SHEARON HARRIS NUCLEAR POWER PLANT, UNIT NO. 1
DOCKET NO. 50-400/RENEWED LICENSE NO. NPF-63
RESPONSE TO REQUEST FOR ADDITIONAL INFORMATION REGARDING THE LICENSE AMENDMENT REQUEST TO REVISE TECHNICAL SPECIFICATION 3.7.5a, ULTIMATE HEAT SINK MAIN RESERVOIR MINIMUM LEVEL

SHEARON HARRIS NUCLEAR POWER PLANT, UNIT NO. 1
DOCKET NO. 50-400/RENEWED LICENSE NO. NPF-63
RESPONSE TO REQUEST FOR ADDITIONAL INFORMATION REGARDING THE LICENSE AMENDMENT REQUEST TO REVISE TECHNICAL SPECIFICATION 3.7.5a, ULTIMATE HEAT SINK MAIN RESERVOIR MINIMUM LEVEL

Enclosure 2
Response to the June 11, 2009, Request for Additional Information Regarding the License Amendment Request to Revise Ultimate Heat Sink Main Reservoir Minimum Level
(5 Pages)

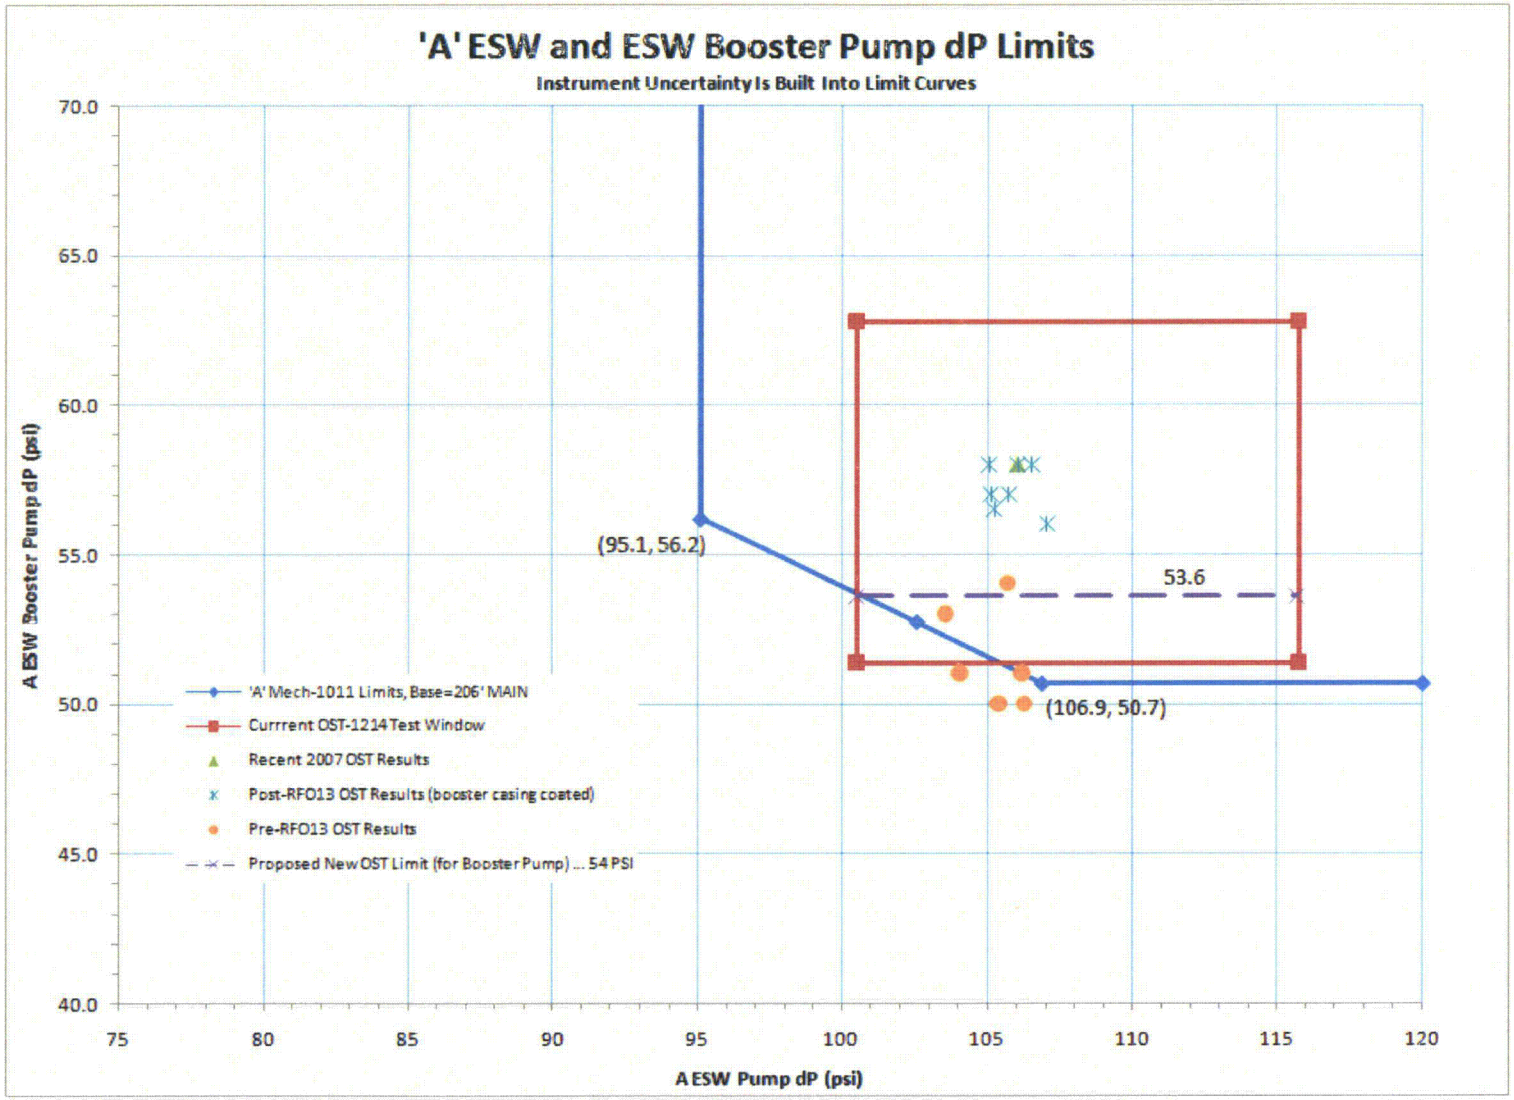
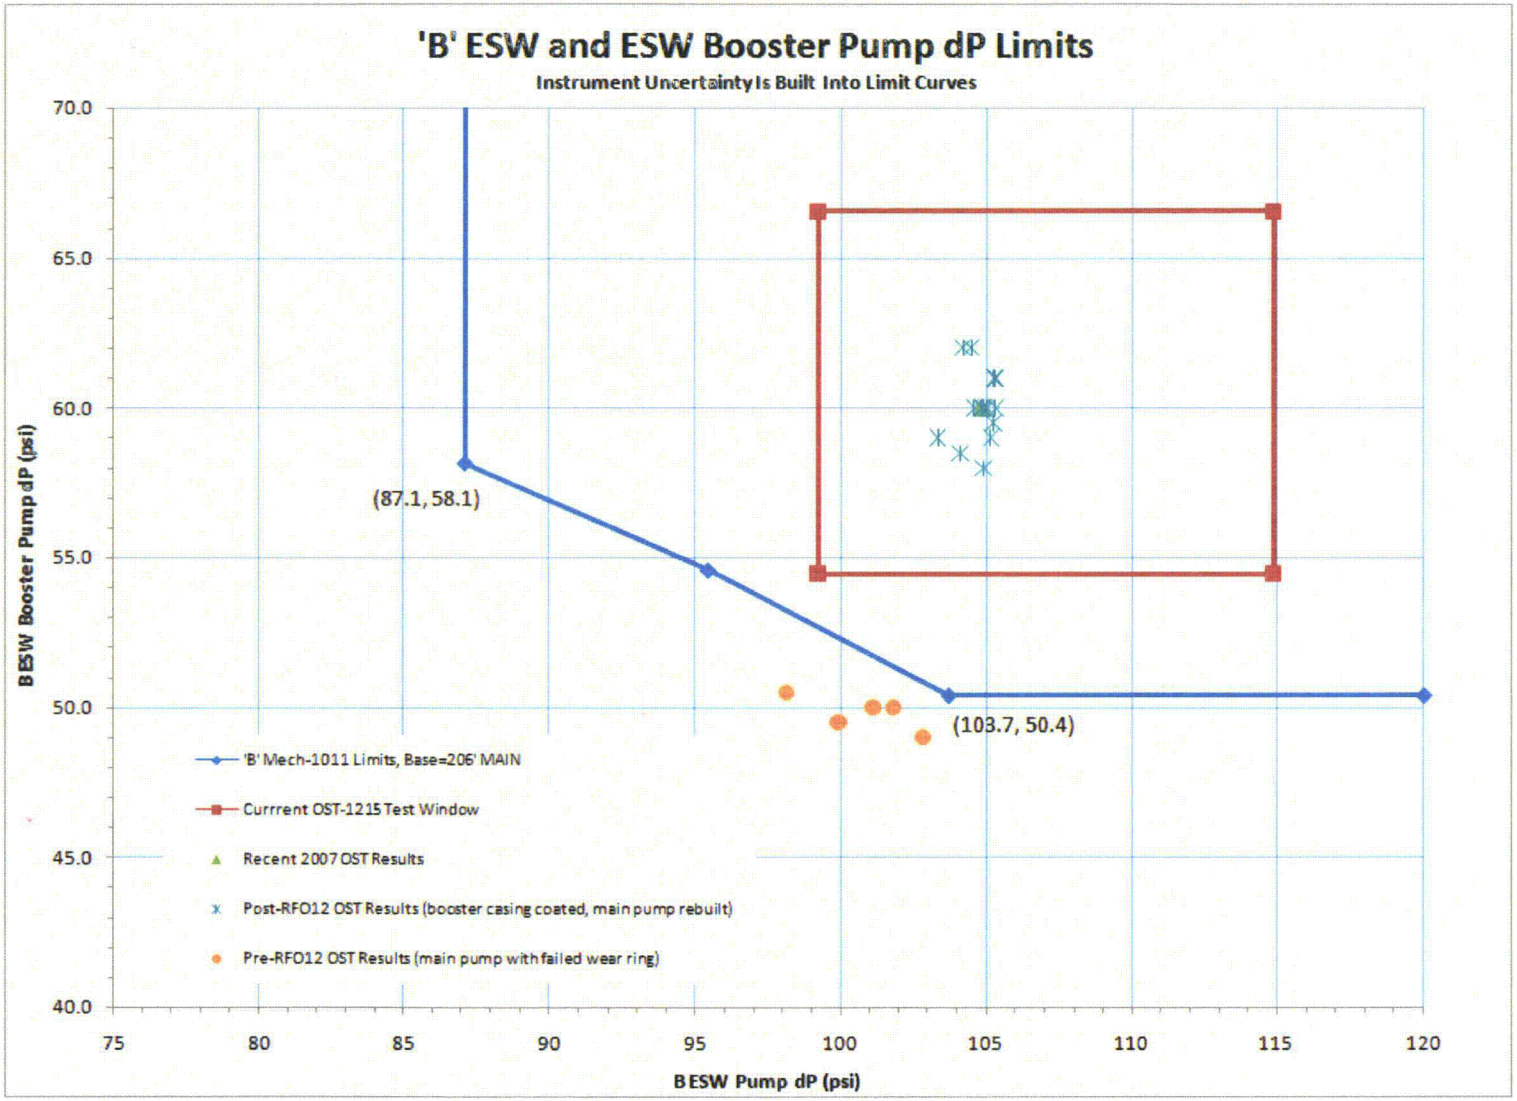
Section 4.2 of the LAR states that calculation HNP-M/MECH-1011 demonstrates that there is positive pressure margin available with a 206 feet minimum level in the Main Reservoir. Since the ESW Pumps and the ESW Booster Pumps both contribute to ESW pressure inside containment, the figures shown in the submittal provide the minimum allowable pump differential pressures for both pumps of each train on a single graph. The NRC staff is not clear as to how the licensee generated the figures in the LAR shown on pages 10 of 23 and 11 of 23, and how these figures demonstrate that the licensee will continue to meet the minimum service water pressure requirements inside the containment coolers.

Request 7: *Section 4.2 of the LAR states that the results of calculation HNP-M/MECH-1011 show that ESW pressure, not flow, currently defines the available ESW system margin. Do the differential pressure limits shown in the figures on pages 10 of 23 and 11 of 23 in the LAR reflect limits based on ESW flow or ESW pressure or both? Please explain.*

Since the ESW Pumps and ESW Booster Pumps both contribute to ESW pressure inside containment, HNP-M/MECH-1011 provides the minimum allowable pump differential pressures (dP) for both pumps for each train on a single graph. This allows for various combinations of limits between the ESW and ESW Booster Pumps. The calculation also graphs the current Operations Surveillance Test (OST) limits and some recent and historical OST data against the new pump dP limits. These graphs are shown on pages 12 and 13 of Enclosure 1.

Each graph shows the limits of pump performance based on the ability to maintain ESW pressure above 41.8 PSIG. Because the ability of the ESW system to maintain minimum pressure is more limiting than the ability to provide minimum flow, all areas on the graph which ensure acceptable system pressure also ensure acceptable system flow.

In these graphs, the box labeled "Current OST-1214(1215) Test Window" represents the current OST limits for the ESW and ESW Booster Pumps. The two vertical (left and right) sides of this box represent the current minimum and maximum OST dP limits for each ESW Pump. Similarly, the two horizontal (top and bottom) sides represent the current minimum and maximum OST dP limits for each ESW Booster Pump. Note that

the lower left corner of the 'A' OST window is truncated by the "A Mech-1011 Limits..." curve (described below). As a result, the dashed line on the 'A' graph represents the proposed change to the 'A' ESW Booster Pump lower limit resulting from the new Main Reservoir limit of 206 FT.

The "A(B) Mech-1011 Limits..." curve represents the minimum acceptable combination of ESW Pump and ESW Booster Pump dP values required to ensure that containment fan cooler discharge pressures remain above 41.8 PSIG. As long as the combination of ESW Pump dP (x-axis) and ESW Booster Pump dP (y-axis) remains above and to the right of this curve, fan cooler discharge pressure will meet or exceed 41.8 PSIG when the Main Reservoir is at 206 FT.

Response 1: Reference revised Enclosure 1, "HNP Evaluation of the Proposed Change," page 10. Note that the figures on pages 10 of 23 and 11 of 23 referenced above in RAI 2 were based on the original submittal. These figures are now located on pages 12 of 24 and 13 of 24 of revised Enclosure 1.

Response 7: Reference revised Enclosure 1, "HNP Evaluation of the Proposed Change," page 9. Note that the figures on pages 10 of 23 and 11 of 23 referenced above in RAI 2 were based on the original submittal. These figures are now located on pages 12 of 24 and 13 of 24 of revised Enclosure 1.
